ADDENDUM #4

Will County Health Department
BID PACKAGE #3 – MEP/Finishes/Carpentry/Glazing
December 6, 2018

RFI LOG
Will County Health Department
Bid Package #3 Addendum #4 12/6/18

PARTIAL SECOND FLOOR PIPING PLAN - AREA 'A'

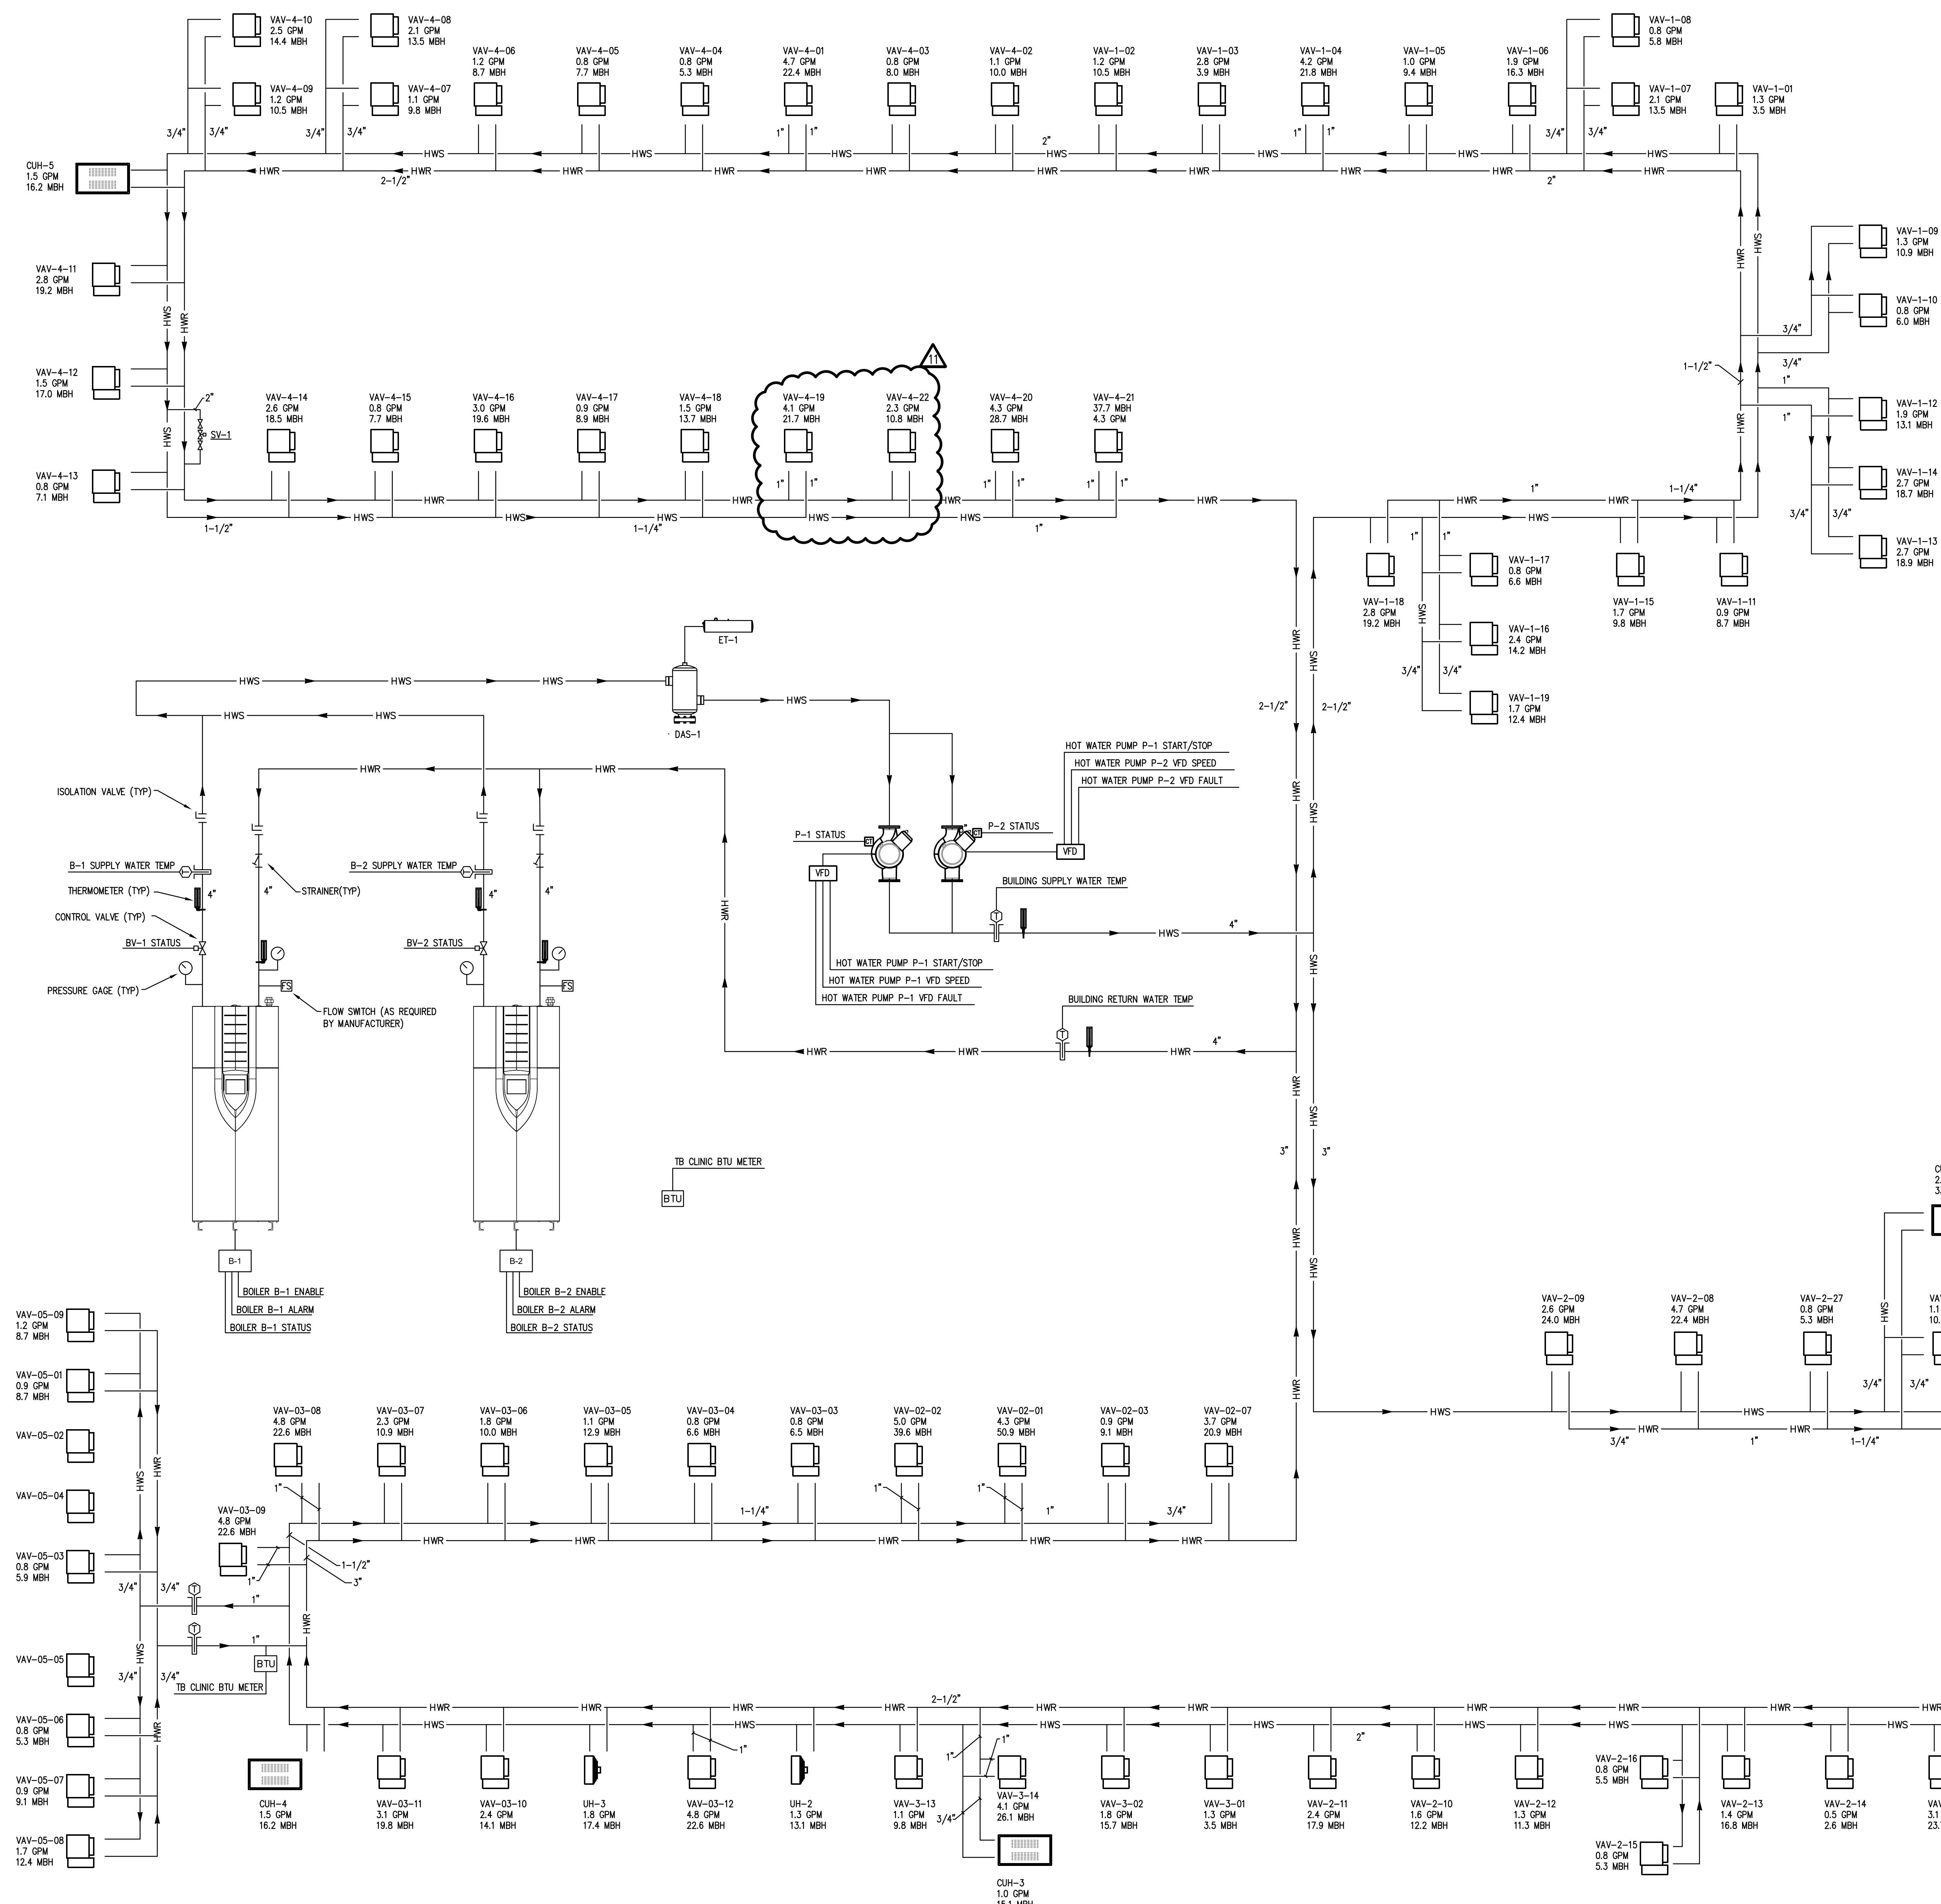
2.12 DRAWING M421 - PARTIAL SECOND FLOOR PIPING PLAN - AREA 'A'

| SHEET NUMBER | P311 |

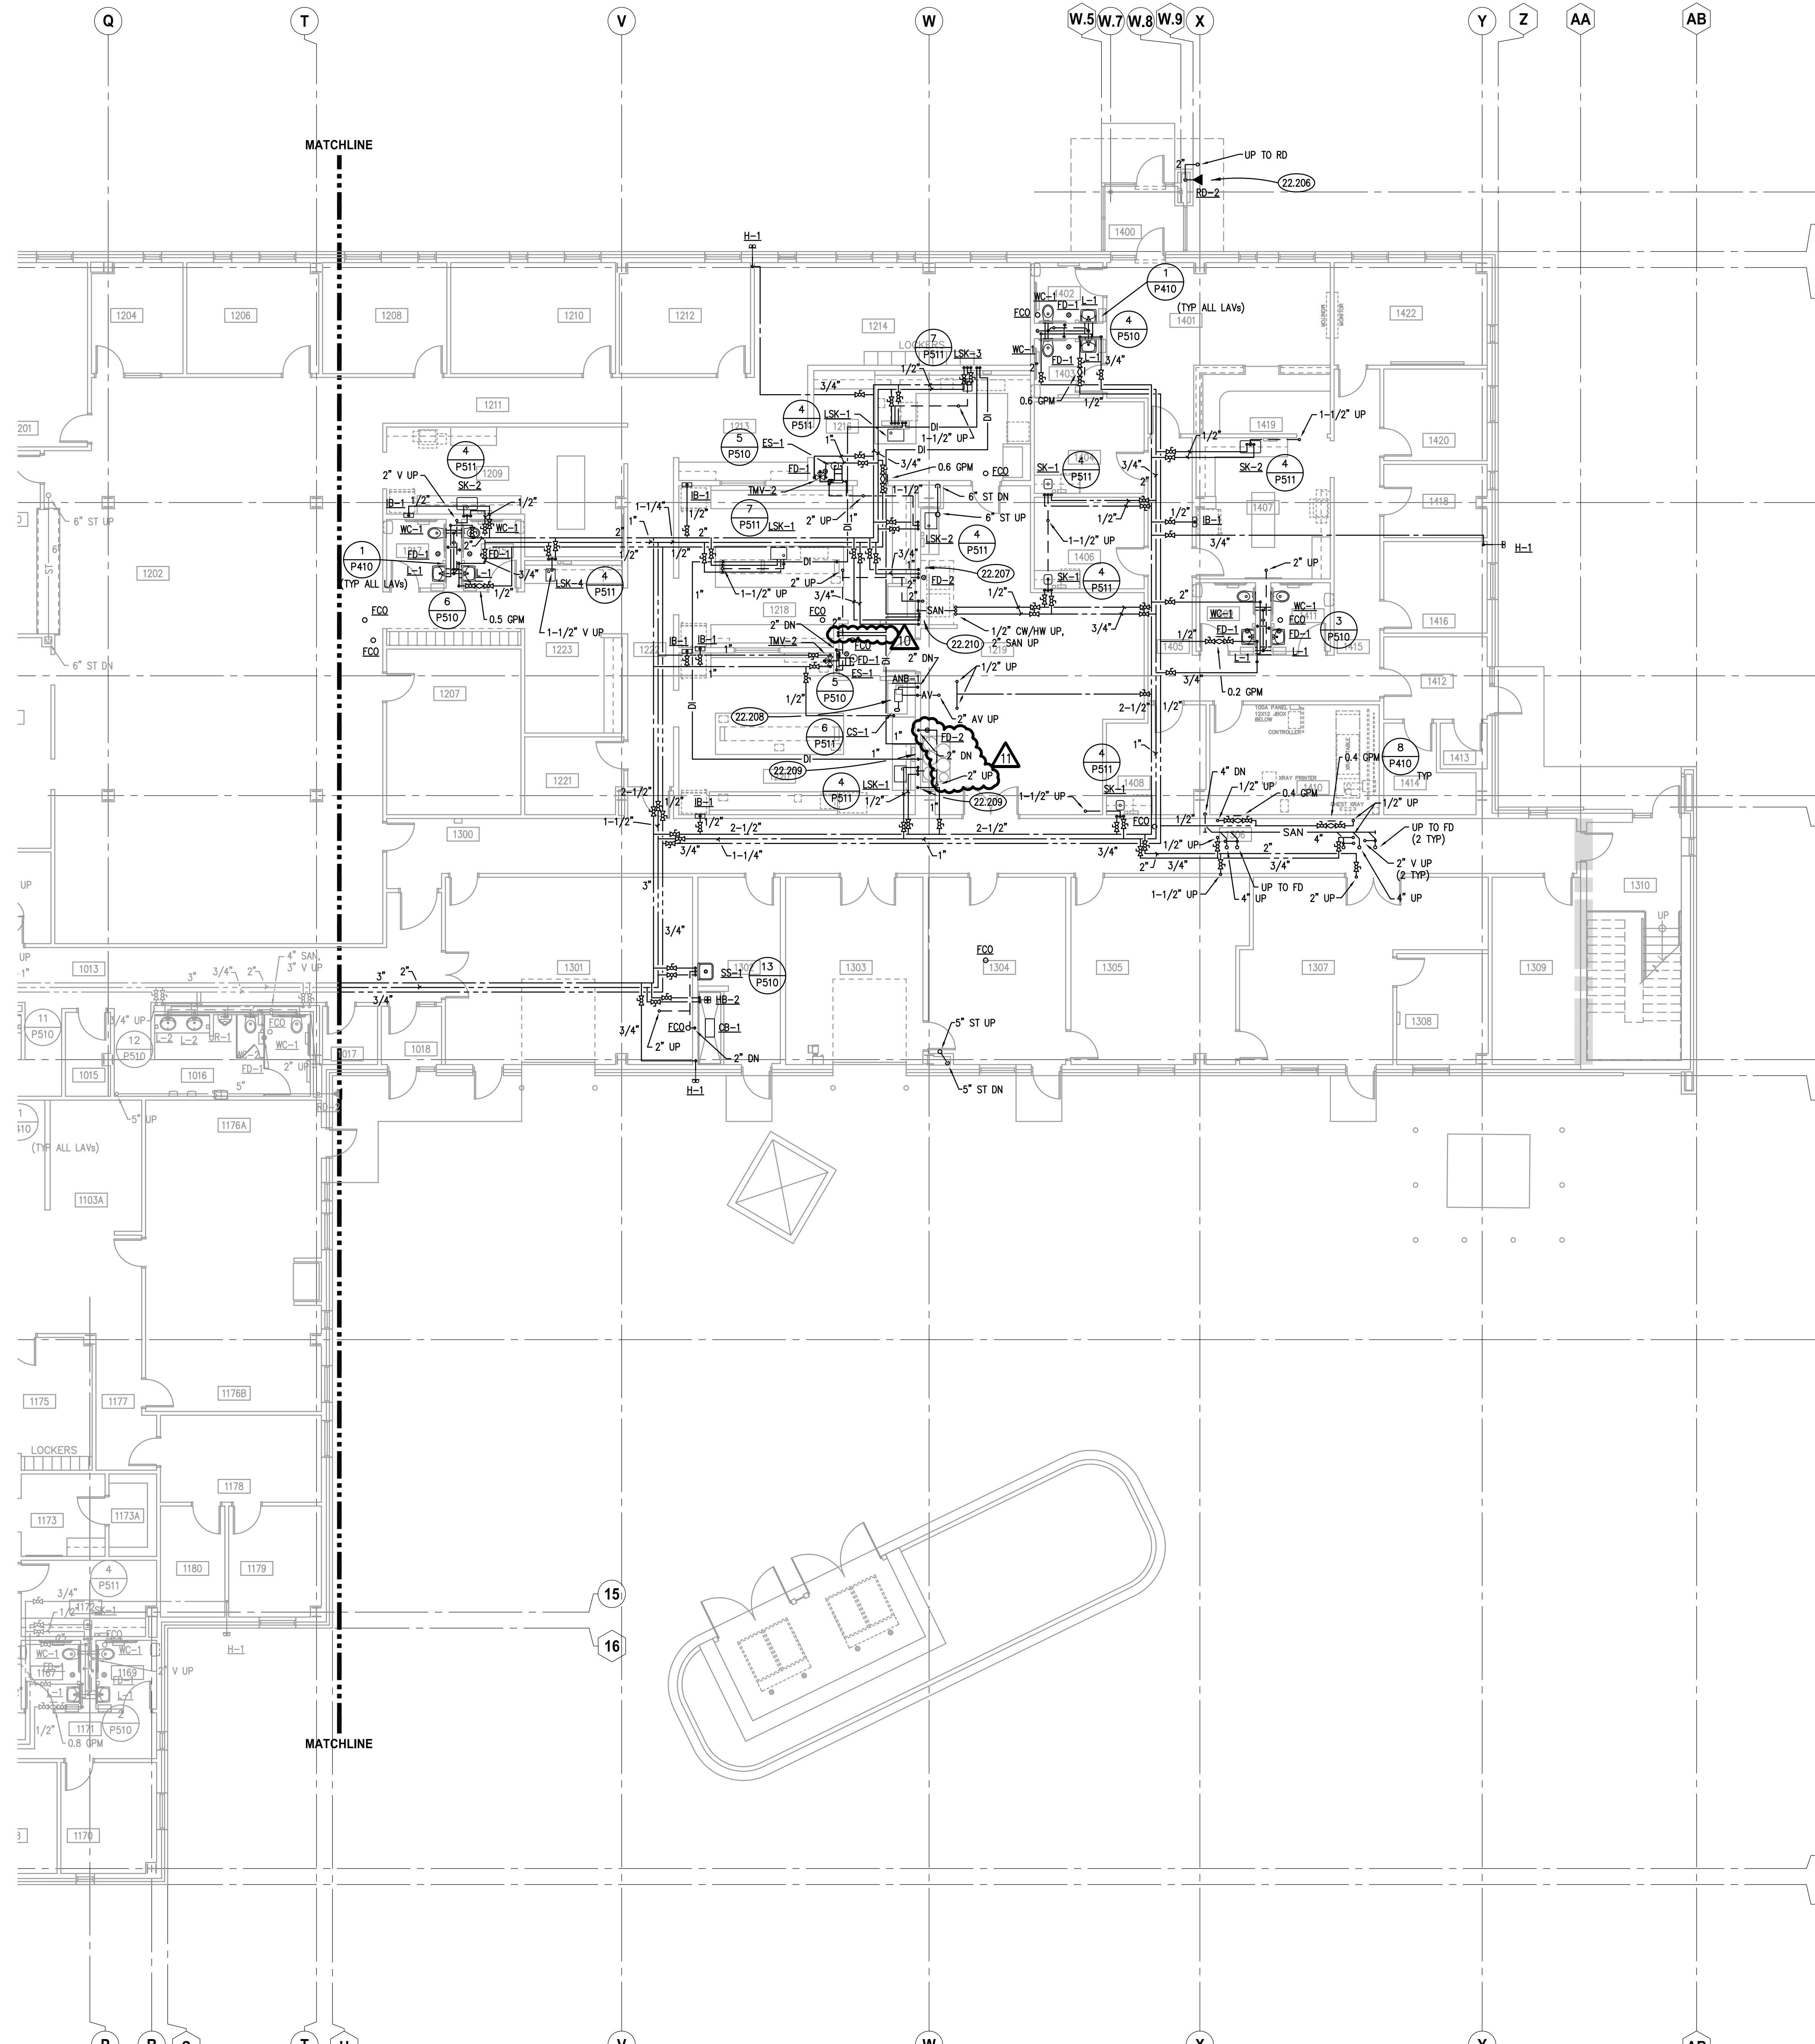
2.16 DRAWING P311 - PARTIAL UNDERGROUND PLUMBING PLAN - AREA 'A'

P312

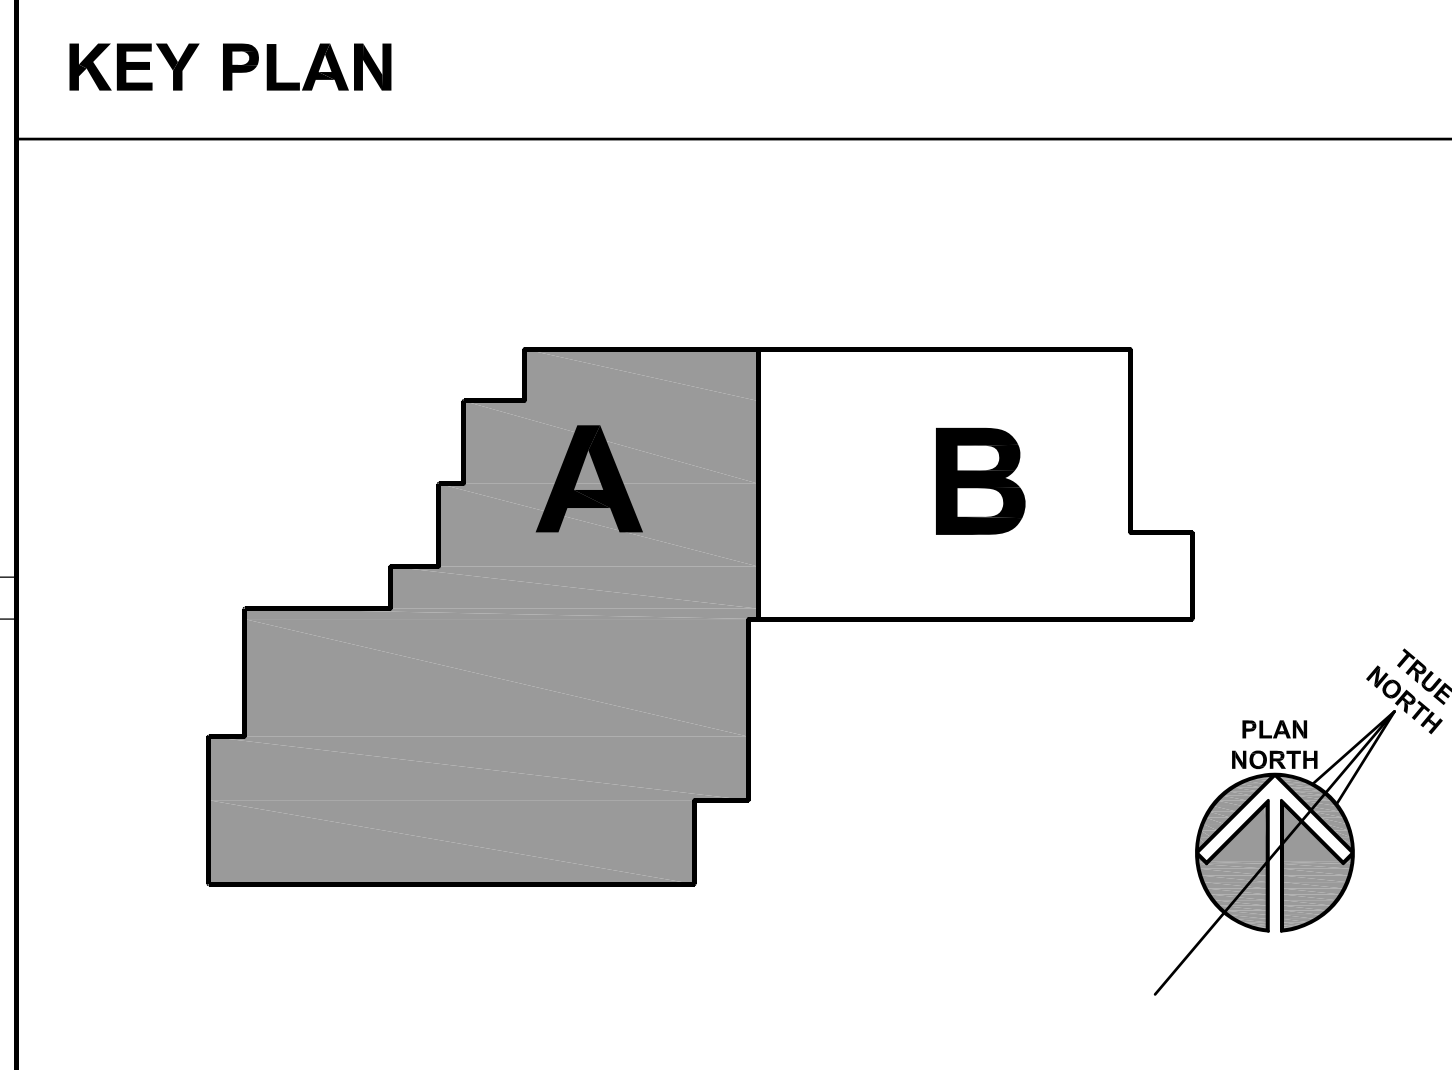
2.17 DRAWING P312 - PARTIAL FIRST FLOOR PLUMBING PLAN - AREA 'B'
